MECCEMA 1 : ORDINARY RESOLUTIONS - PROPOSED CHANGES TO THE GENERAL DESIGN AND DEVELOPMENT CODE 28-08-2021

Key motivation for changes: In order to modernise and add value to homes on the Estate the P&A Committee would like to propose the following changes to the General Design and Development Guidelines as ordinary resolutions. Aside from the proposed changes below, the General Design and Development Guidelines will henceforth be known as the “General Design and Development Code”.

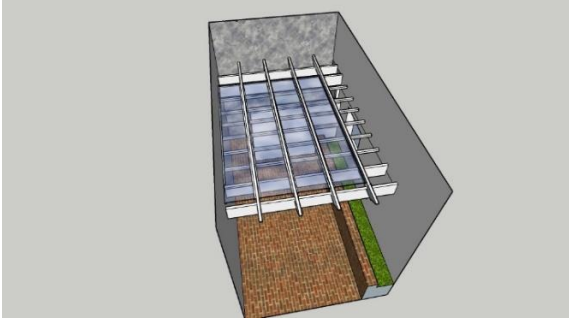
24 Clause 5.4 permits pergolas in hardwood, UPVC or aluminium. No detail regarding roofing.

24 **PERGOLA / GAZEBO / OUTDOOR STRUCTURE**
 Recommend: Open or roofed to be permitted
 White open slatted timber or aluminium posts and beams or UPVC, enclosed in flat polycarbonate sheeting only (clear or transparent), safety glass or louvred type shutters (open and retractable) and subject to coverage.

Recommend these are permitted to be enclosed with louvres, frameless stacking glass, timber or powder coated aluminium (white / glass) subject to FAR and coverage; must be retractable (sliding or stacking) and able to open fully.

Clear or opaque roof permitted for pergola roof structure only.

Roof tiles also permitted
